Planning document to support the planning objection

From Gordon Layne

Planning Application CB/17/00293/FULL

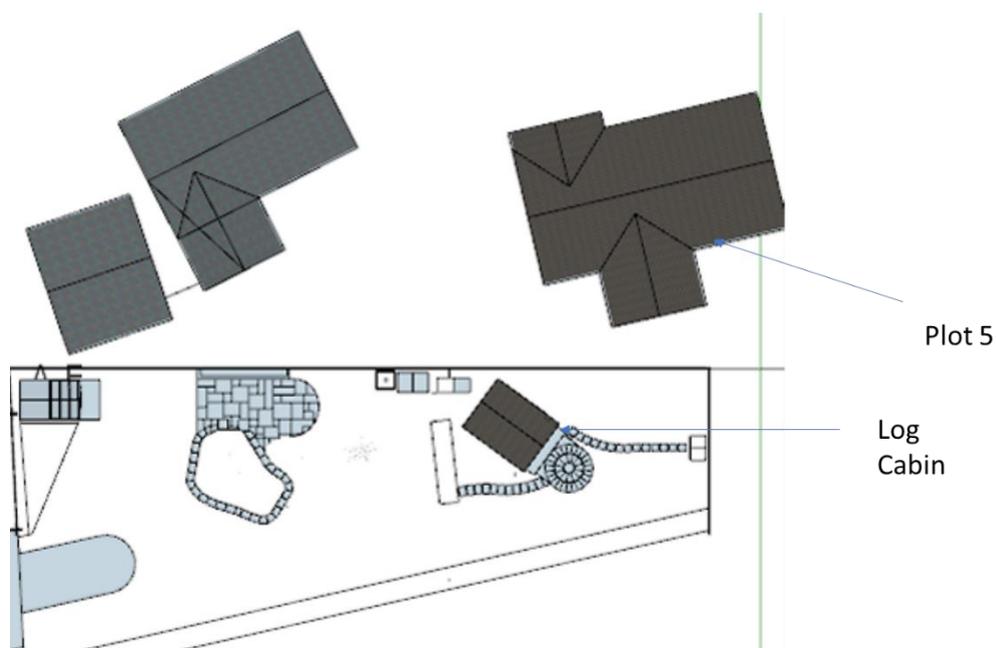
The major concern however relates to the location of Plot 1 coupled with no footpath on the plot. The plan provided indicates traffic will be parked away from the entrance of the site. This is a best case situation and will not be the defacto parking provision by the occupants and visitors to the site. Additionally since, indicated in section 2, the on road parking is only 50% of that required ( 2 parking spots allocated whereas there should be 4). Some on road parking needs to be allocated elsewhere on the estate and since the parking for plot 1 the norm would be for one car to be in close proximity of the building.

Vehicles will park between Plot 1 and the High Street and this will affect the view of any one entering the site particularly if parked on the bend brought about by Plot 1s position.

(a) Base of the wall to the main premises

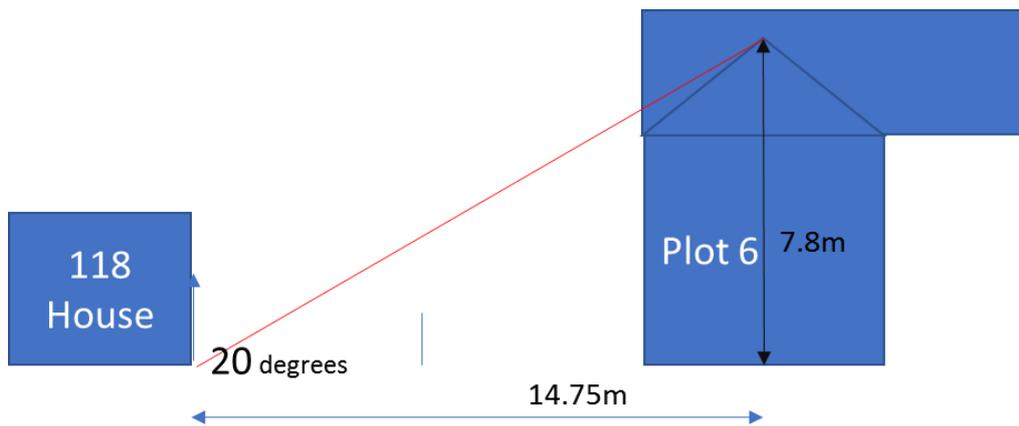
1. 118 High Street is adjacent and virtually to the North of Plot 6.
2. From the plans submitted to support the development the following dimensions have been estimated. Please note to ensure the best case and not the worst case the dimensions have been takes from the secondary ridge identified in Red and not the maid ridge, which is circa 80cm below the main ridge and 3 metre further South.

3. From these the following angles have been calculated.

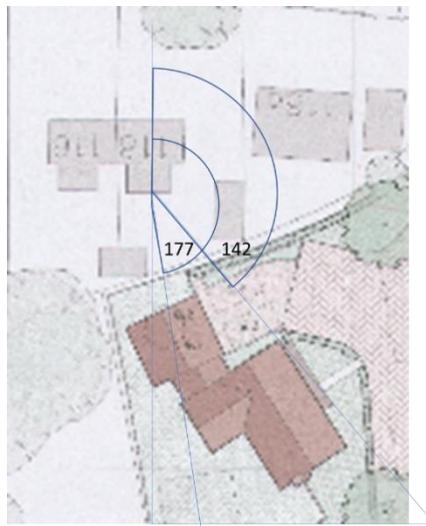
4. From the diagram the best case angle is between 142 from Due North and 177 from Due North.
